September 22, 2008

Chief, Rulemaking, Directives and Editing Branch
Division of Administrative Services
Office of Administration
Mailstop T-6D 59
US Nuclear Regulatory Commission
Washington, DC 20555-0001

RE: Environmental scoping for the relicensing of the Prairie Island Nuclear
Generating Plant, Units 1 and 2

Figure 2.

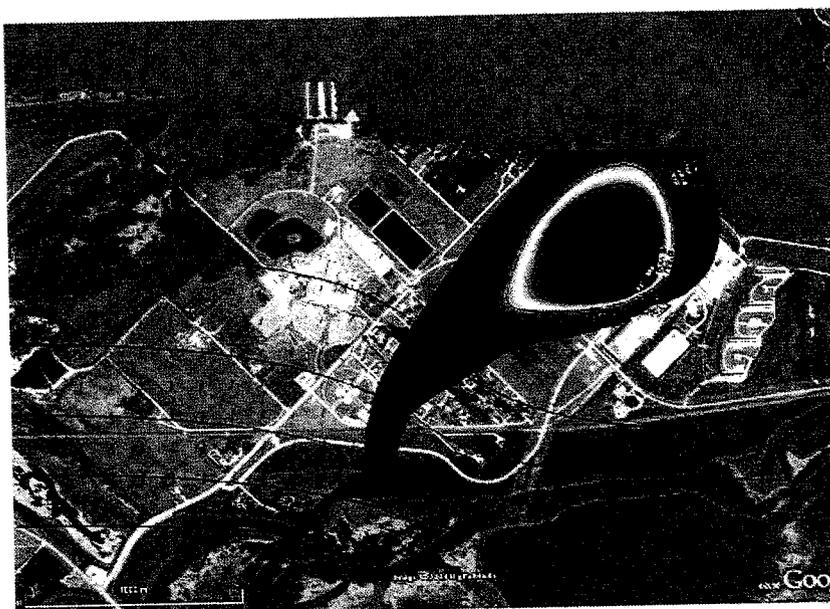
Figure 2, below, represents a simulated groundwater modeling showing the movement of tritium from the PINGP towards the Prairie Island Indian Community. The Community respectfully demands a full and complete disclosure of the monitoring data for all tritium and other radiological contaminants for each well or other monitoring location, and not simply monthly, quarterly or annual averages for individual wells. This data is critical to identify and baseline accidental and planned releases of tritium and other radiological contaminants, and to facilitate the Community's preparation of exposure scenarios, scenario analysis, and computer modeling of all environmental pathways for tritium contamination.

- The higher tritium concentration in onsite wells indicate that PINGP is the tritium source of PIIC wells (see Figure 2);
- No explanation was provided for off-site residence well contamination of tritium since 1989;

The SEIS must include an accurate quantification of radiological impacts to the members of the Prairie Island Indian Community—from all sources. At a minimum, the SEIS should include all data associated with all tritium and other radiological releases (accidental and planned), and all of the data for each well or other monitoring location (and not simply monthly, quarterly or annual averages for individual wells). This data is critical to identify and baseline accidental and planned releases of tritium and other radiological contaminants, and to facilitate the Community's preparation of exposure scenarios, scenario analysis, and computer modeling of all environmental pathways for tritium contamination.
